SUBJECT: Part 21 rept re potential defect in Swagelok stainless steel front ferrule, part number SS-503-1 which was machined with improper length. C/A includes insp equipment that will 100% identify short length.

Subject: Defects Potentially Reportable under 10CFR part 21

We are writing about a potential defect in a Swagelok stainless steel front ferrule, part number SS-503-1. The part is marked with the heat code IVD on it. The front ferrule is shipped as a component in a Swagelok tube fitting, or sold as a replacement part.

A sales drawing that shows a proper ferrule and one with the short length is enclosed.

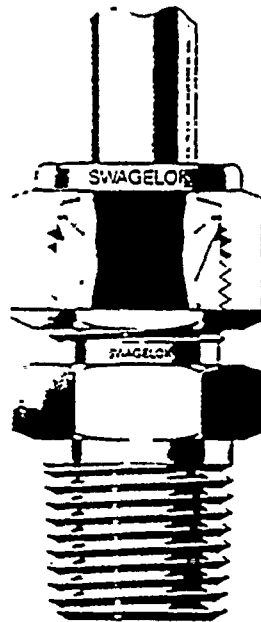
The potential problem is that the ferrule was machined with an improper length, resulting in the 45 degree chamfer at the trailing edge to be missing. Laboratory testing of this part has shown that it will leak immediately on gas service, and will hold to about 2.5 times working pressure of the tubing during a hydraulic pressure test.

The improper length was caused by insufficient feedout of the bar on a multiple spindle machine. Our analysis shows that this would be a first part error and that only a small number of ferrules are affected. Our automated assembly equipment is set to reject this condition, and of the parts that were not sent through automated assembly, about one per cent of the lot is included.

Corrective action includes inspection equipment that will 100 per cent identify this short length.
